Development Services

APPEAL SUMMARY

Appeal ID: 16549	Project Address: 3714 SW Macadam Ave	
Hearing Date: 2/28/18	Appellant Name: Jeancarlo Saenz	
Case No.: B-005	Appellant Phone: 9727269400 x106	
Appeal Type: Building	Plans Examiner/Inspector: Maureen McCafferty	
Project Type: commercial	Stories: 8 Occupancy: R-2, M, S-2, A-3 Construction	
	Type: Type I-A & Type III-A	
Building/Business Name: Block 40	Fire Sprinklers: Yes - Thorughout	
Appeal Involves: Erection of a new structure	LUR or Permit Application No.: 17-110666-LU	
Plan Submitted Option: pdf [File 1]	Proposed use: Multifamily residential and retail

HIGH-RISE DEFINITION:

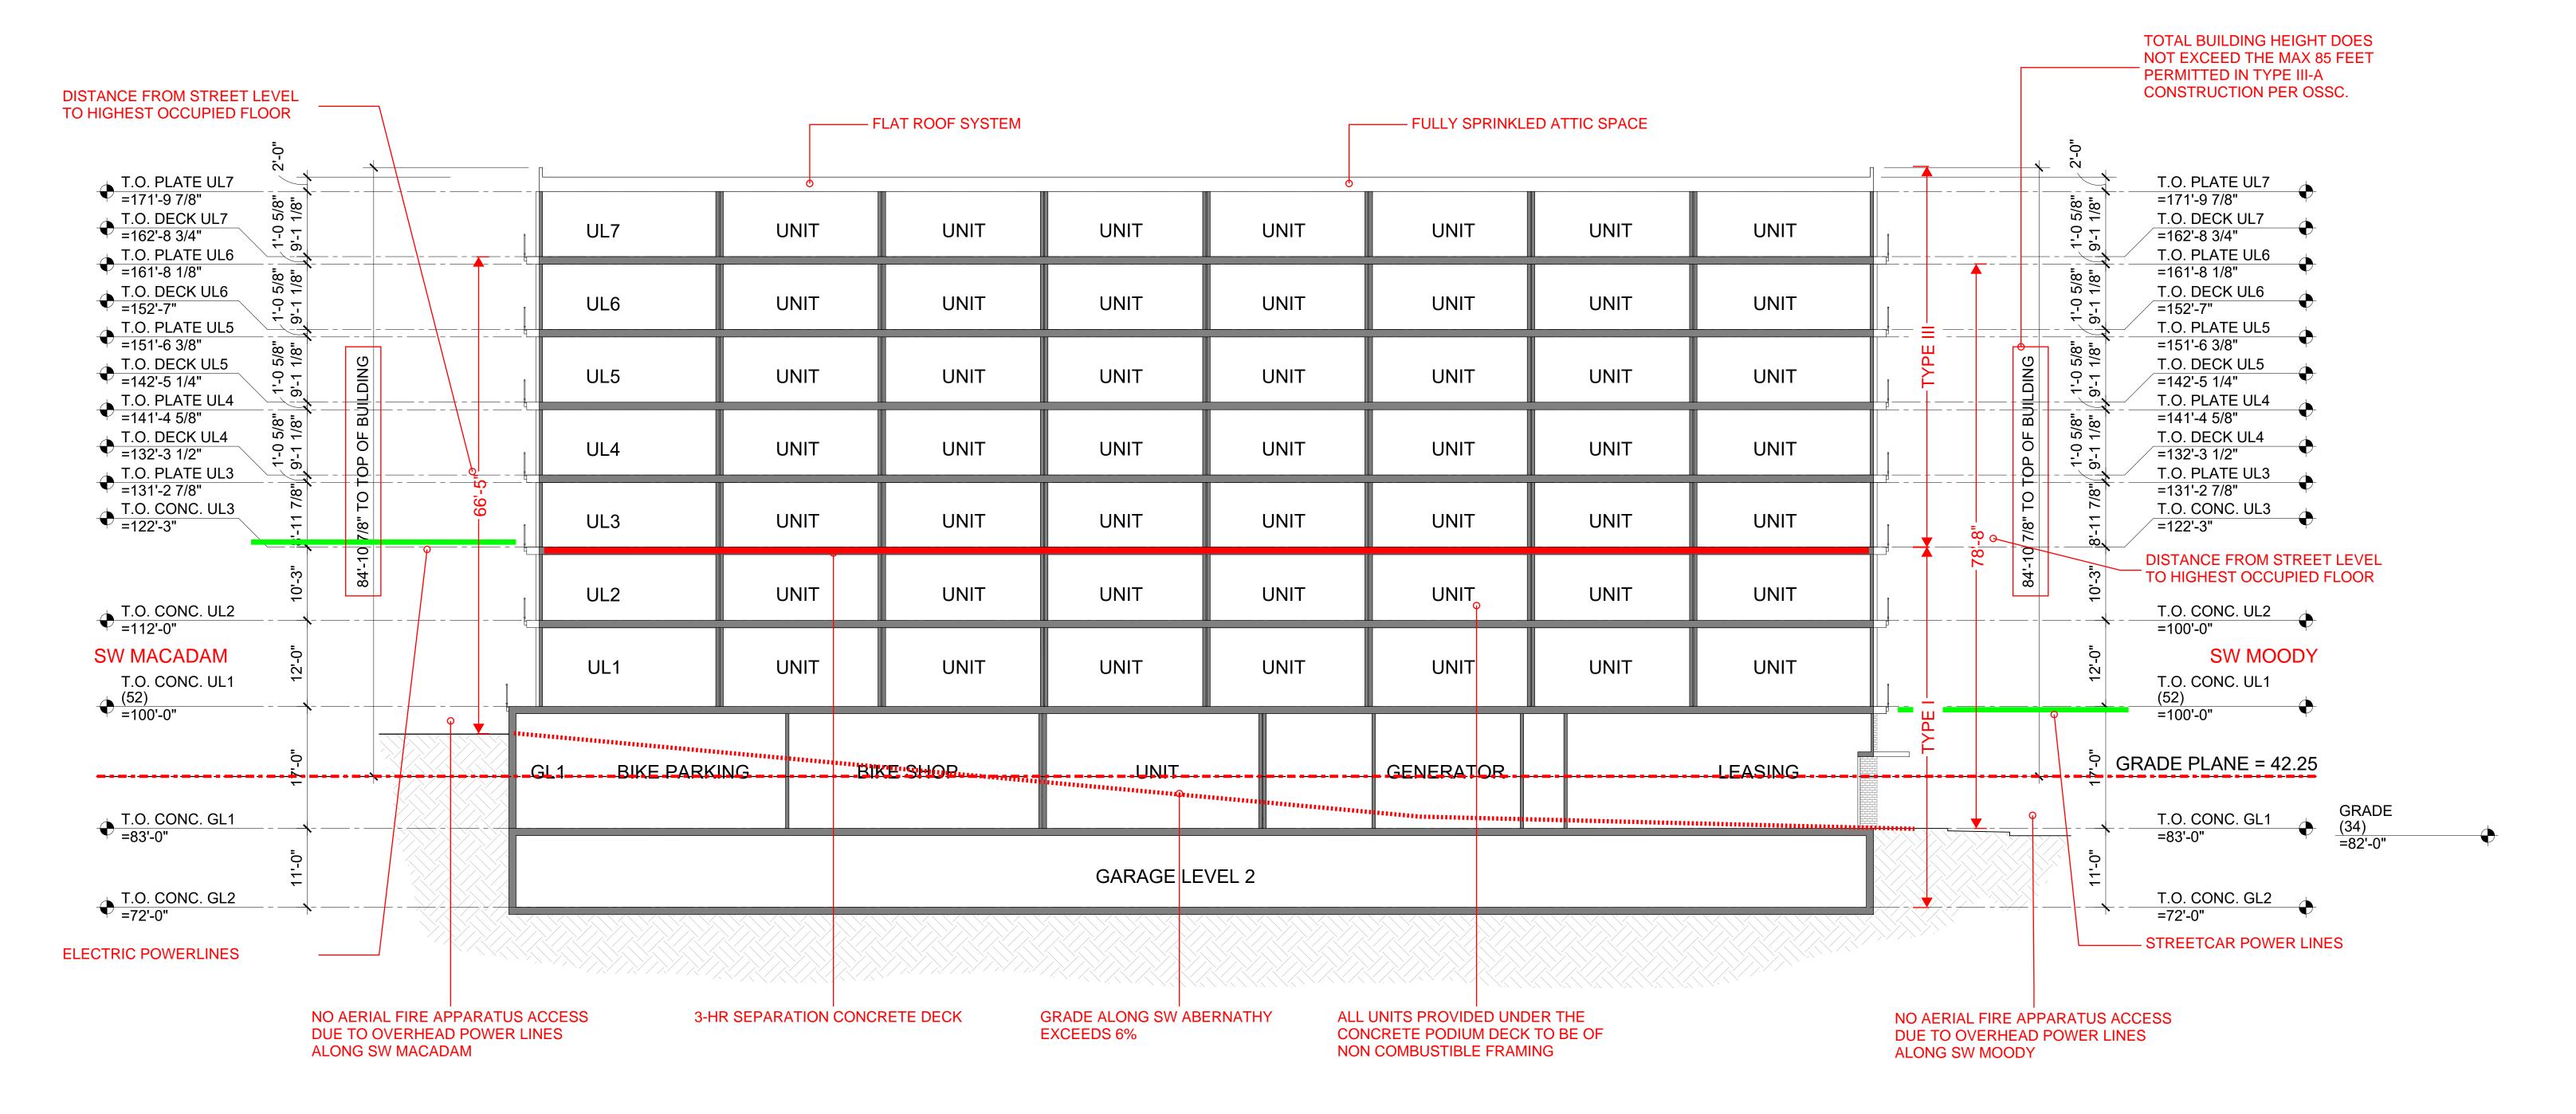
The proposed building is an 8 story (5 over 3) structure that due to grade conditions it exceeds the limits of the 75 feet high-rise limits on one corner of the building only. Out of 227 units, only 4 units fall under this requirement. The attached exhibit describes how the majority of the top floor is excluded from the high-rise requirements by having an occupied floor below 75 feet from the lowest street level.

We request that the additional height created by site conditions on a small portion of the building do not trigger the high-rise requirements for this building.

A HIGH-RISE BUILDING IS DEFINED IN CHAPTER 2
OF THE OSSC AS A "BUILDING WITH AN OCCUPIED
FLOOR LOCATED MORE THAN 75 FEET ABOVE
THE LOWEST LEVEL OF FIRE DEPARTMENT
VEHICLE ACCESS.

THE CURRENT SITE CONDITIONS AROUND THIS BUILDING DO NOT ALLOW FOR AERIAL FIRE APPARATUS ACCESS DUE TO GRADE CONDITIONS AND OVERHEAD UTILITIES THEREFORE <u>FIRE DEPARTMENT VEHICLE ACCESS</u> CANNOT BE PROVIDED AND SINCE THE TOTAL HEIGHT OF THE BUILDING DOES NOT EXCEED THE MAXIMUM HEIGHT FOR TYPE III-A CONSTRUCTION, WE FEEL THAT THIS BUILDING SHOULD NOT BE CLASSIFIED AS A HIGH-RISE. ONLY A SMALL SECTION OF THE TOP FLOOR THE BUILDING EXCEEDS THE 75 FT HEIGHT, AS PRESENTED IN THE EXHIBITS IN THIS PACKAGE.

<u>ALTERNATE TO AERIAL FIRE APPARATUS ROADS</u>: Buildings complying with the following conditions will be exempt from the requirements of aerial fire apparatus access roads:

- 1. Building is equipped with an approved automatic sprinkler system, YES
- 2. There are no combustible concealed attic spaces, YES
- 3. All stairway exit enclosures shall have a fire-resistance rating of not less than 2 hours, YES
- 4. The roof is essentially flat (33-perscent slope or less) and, YES
- 5. Approved access is provided to the roof from all stairways. In buildings without an occupied roof, access to the roof from the top story shall be permitted to be by an alternating tread device, a ship stair or ladder that provides a clear width of not less than 30 inches between handrails through a roof hatch or trap door not less than 30 inches (762 mm) wide and 8 feet (2438 mm) long (OSSC 1009).
- 6. Building requiring standpipes are equipped with at least one standpipe that terminates on the roof. YES AND NOT ONE BUT TWO STANDPIPES ARE PROVIDED

- Increase from 1 story to 3 stories of Type IA construction below the 3 hour horizontal separation: Granted provided all provisions of 2015 IBC are met.
- 1a. Vertical offset of horizontal separation per 2018 IBC: Granted as proposed.
- 2. Omission of high rise requirements: Denied. Proposal does not provide equivalent Life Safety protection.
